SITE AS-BUILT LIMITED SITE PLAN MODIFICATION
76 GROVE STREET (LOT 3)
FRANKLIN, MASSACHUSETTS

In response to the applicant's submission of a final Form H for the subject project, we reviewed the final as-built plan, the approved Limited Site Plan Modification from 2008, and performed a site visit. We offer the following comments:

Observed Construction: BETA arrived on-site to perform a conformance observation in conjunction with the Applicant’s for acceptance Form H – Certificate of Completion. The as-built plan, dated June 8, 2022, and Form H were provided by email. BETA walked the site and noted that the project has been constructed in general accordance with the approved plans with the following exceptions/notations:

Date: 7/20/2022 Job No.: 4831-106
To: Mr. Gregory Rondeau, Chairman
Cc:
From: BETA Group, Inc.
Subject: Washington Street (Franklin Flex Space) Field Modification

RED-LINE AS-BUILT GRADING, DRAINAGE AND UTILITIES PLAN

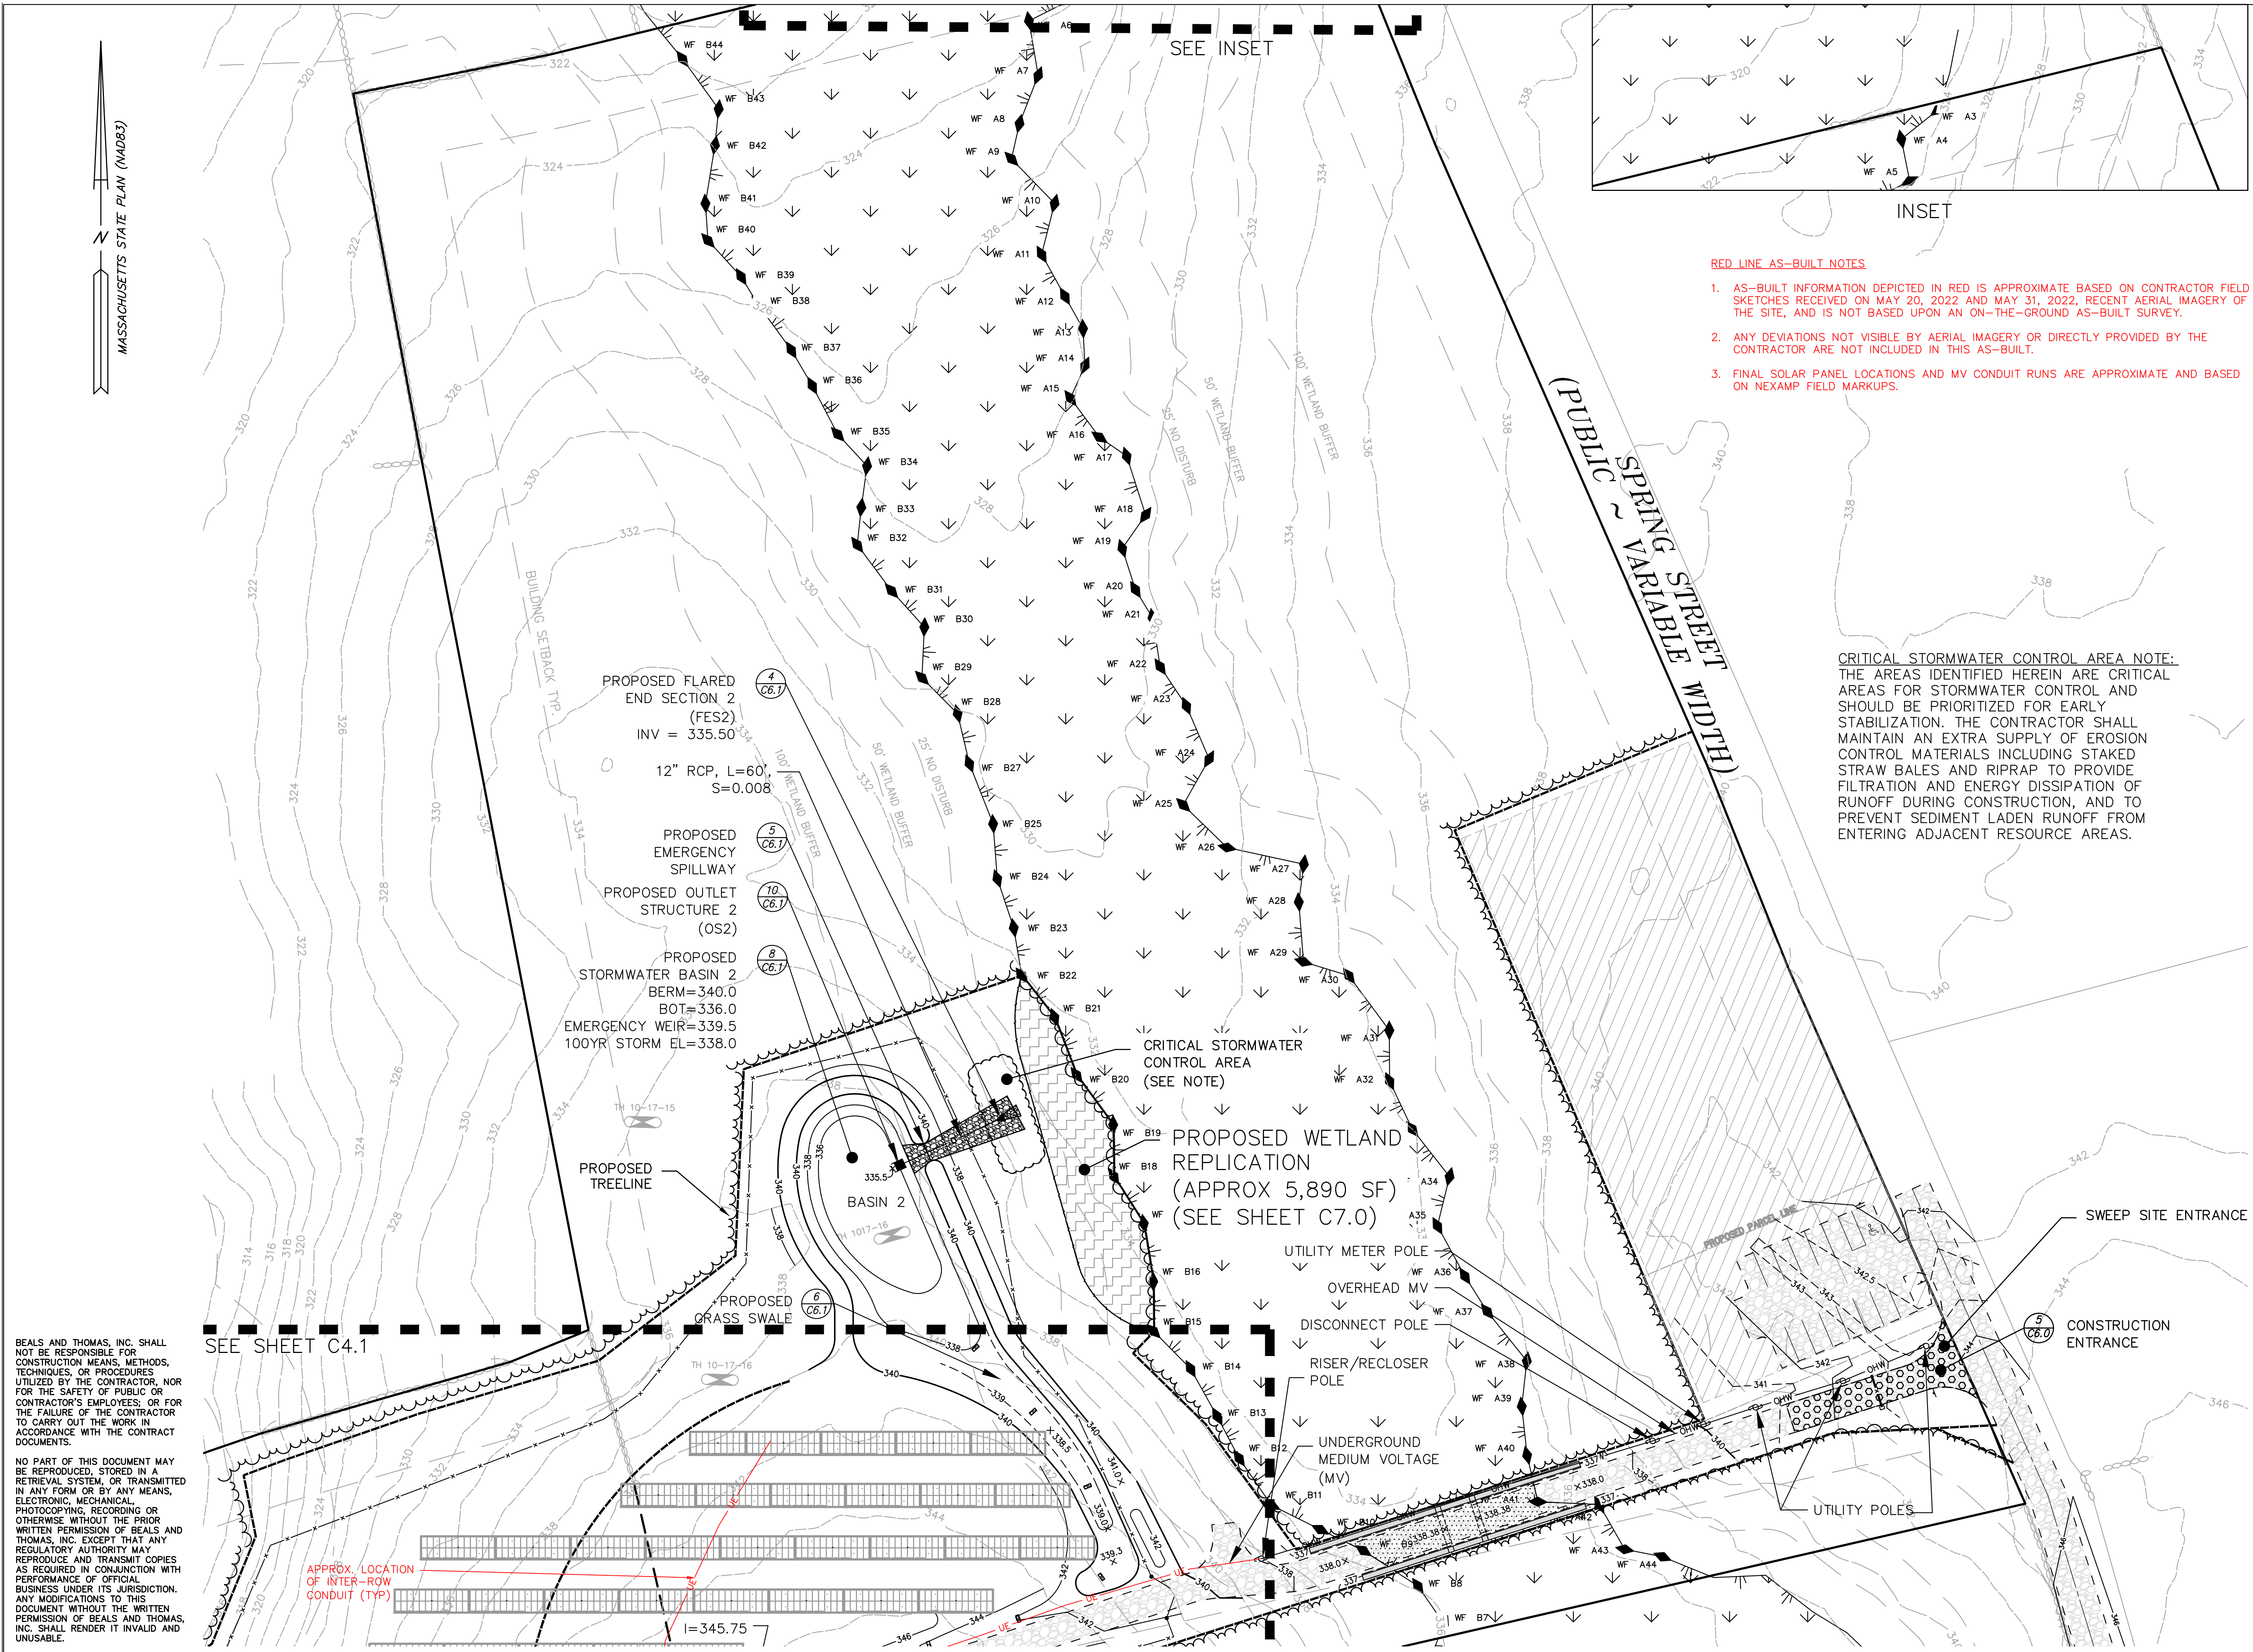
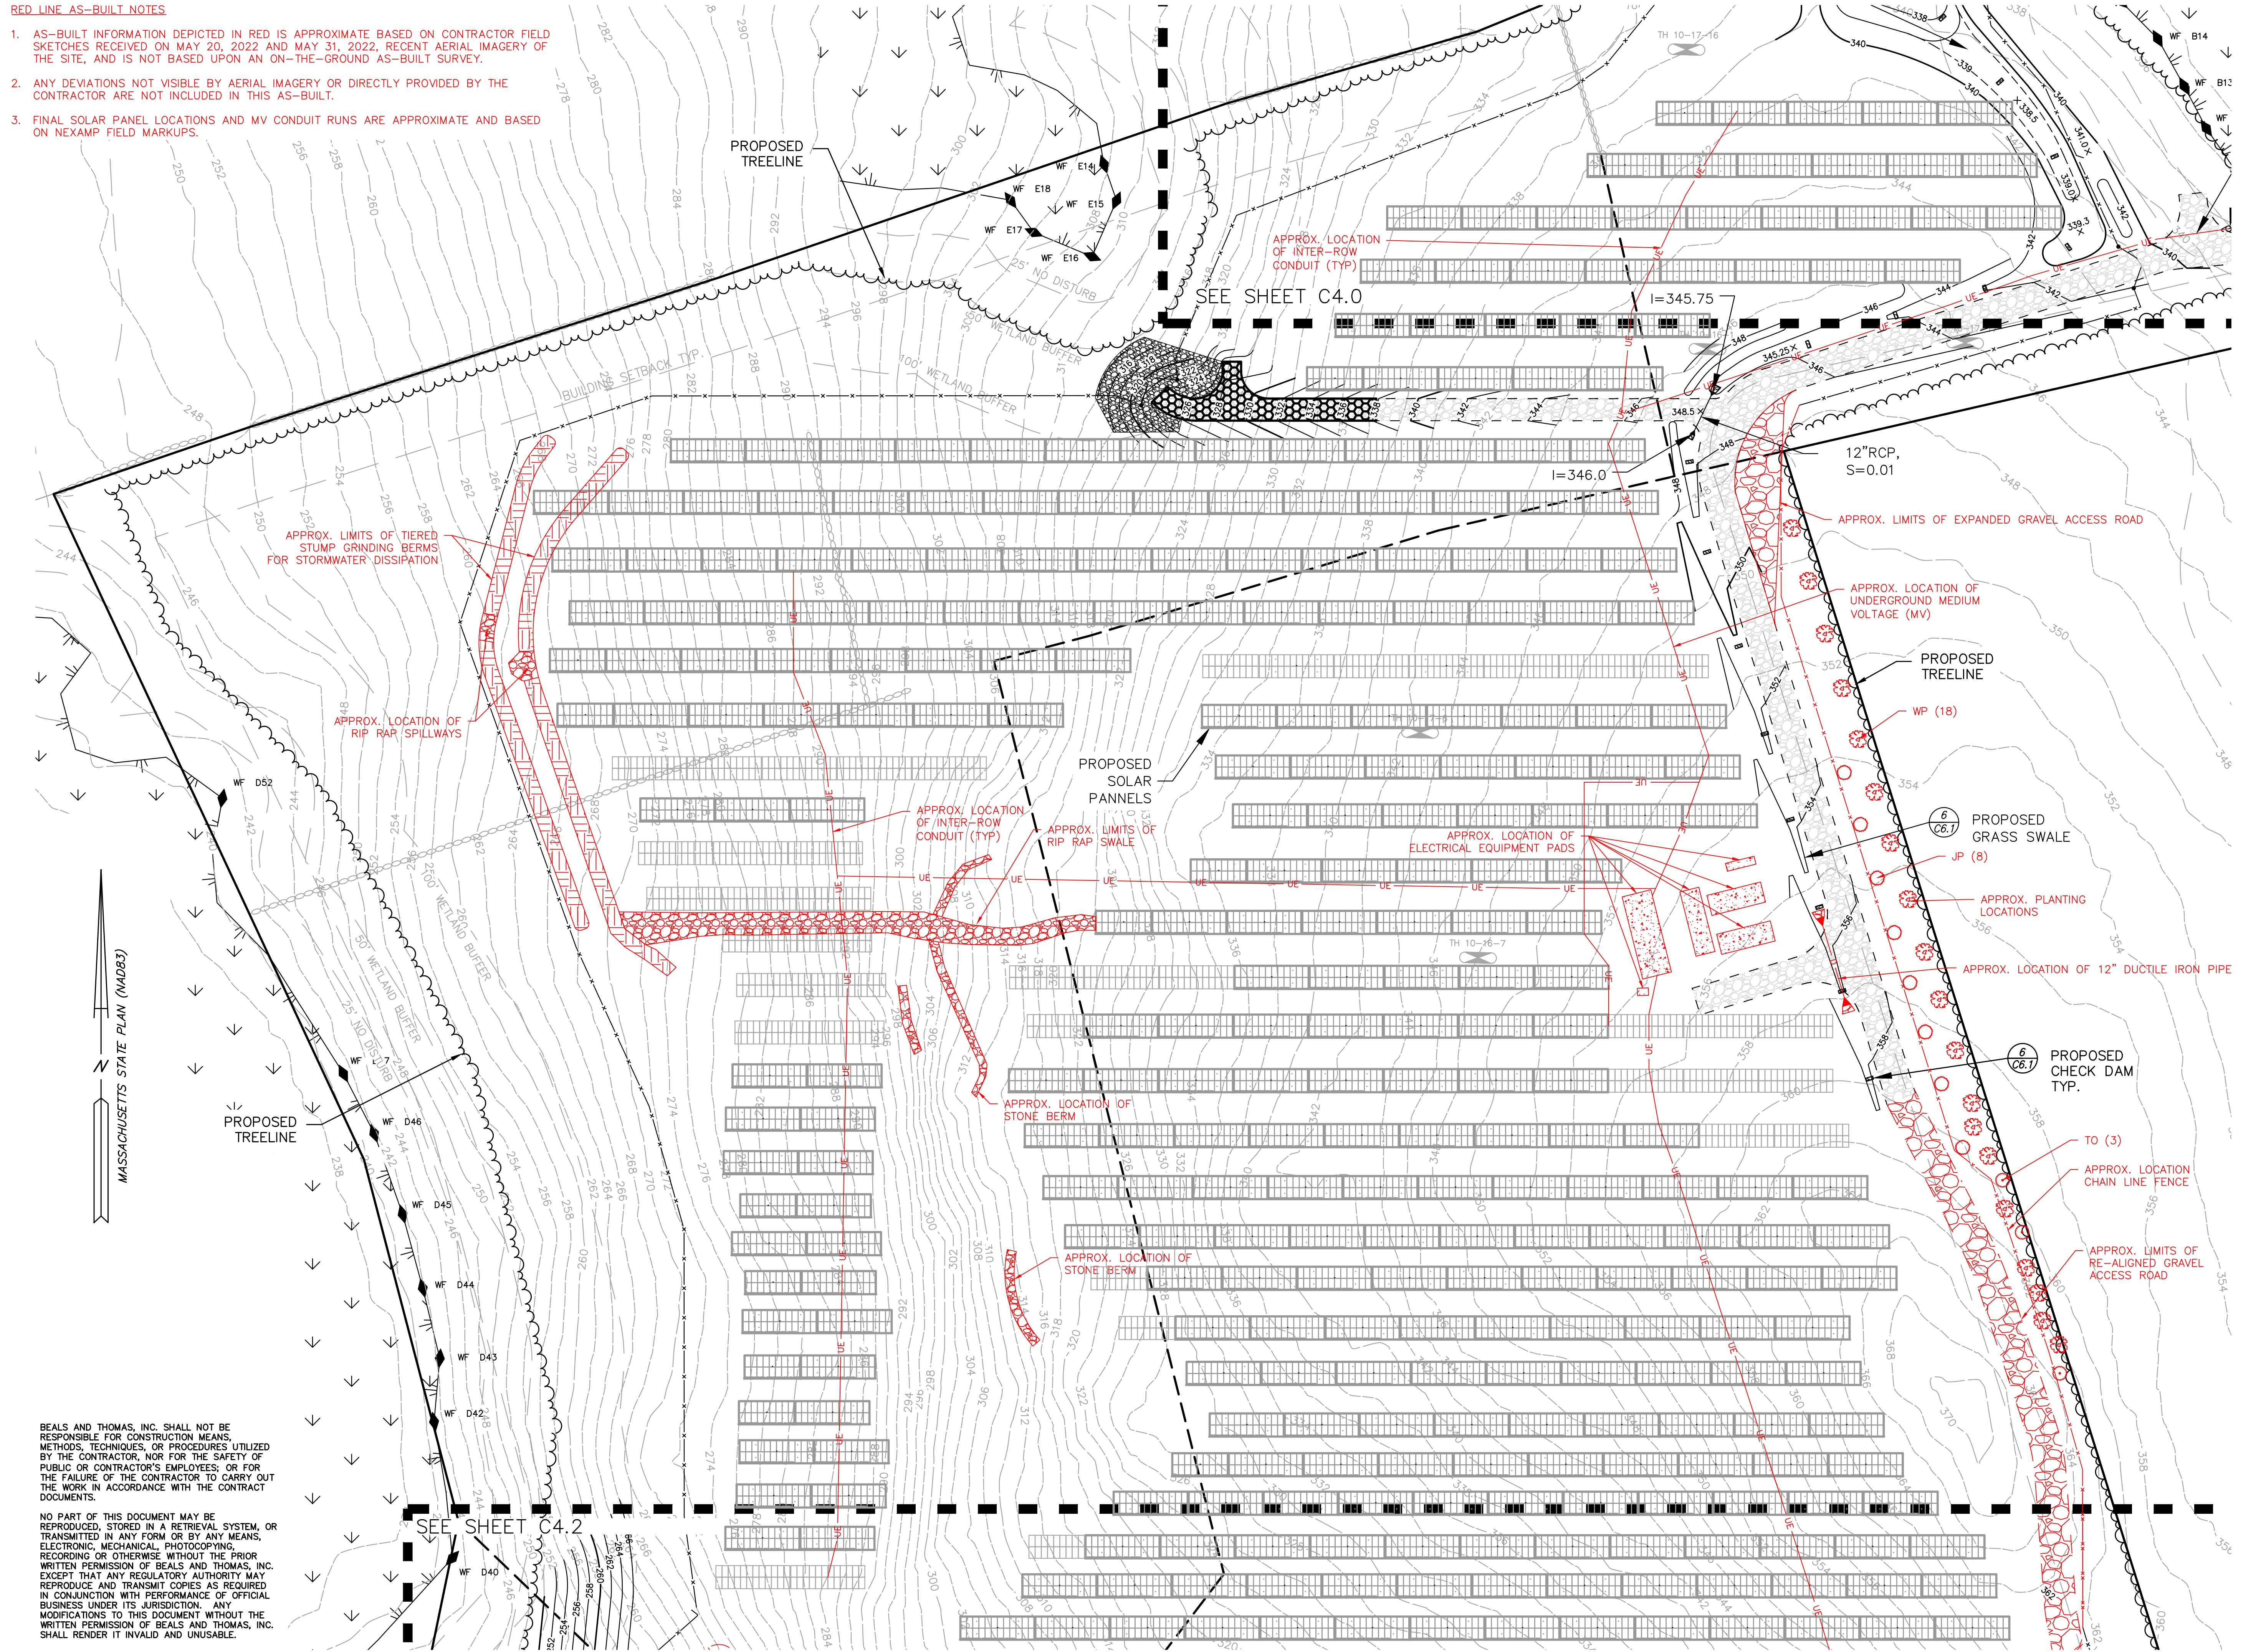
- Red-line notations on the as-built plans including the addition of stump grinding berms for stormwater dissipation, addition of a rip rap swale on the interior of the array area, minor realignments of the gravel access road, and the extension of the gravel access road along the southerly and westerly sides of the arrays. BETA notes these revisions provide improved site stability and adequate access to perform general site maintenance.

- The provided as-built is not based upon field survey. BETA defers to the preference of the Board to provide a fully surveyed plan. At a minimum, BETA recommends for field survey to be performed in the areas of the stormwater basins so storage volumes and inverts can be confirmed.

- The array areas are well stabilized and typically have good vegetative coverage throughout. There are several small areas with limited coverage; however, BETA estimates these represent a very small percentage of the site and remain stabilized.
- Sandbags need to be removed from Infiltration Basin 1 outlet control structure
- Infiltration Basin 1 needs to be maintained to remove wetland vegetation and accumulated silt. BETA notes the infiltrative capacity of the soils was likely impacted by siltation in the early stages of the project when the site was unstabilized. Following removal of vegetation and silt the underlying soils should be scarified and the surface restored with loam and seed in accordance with the Approved Plans.
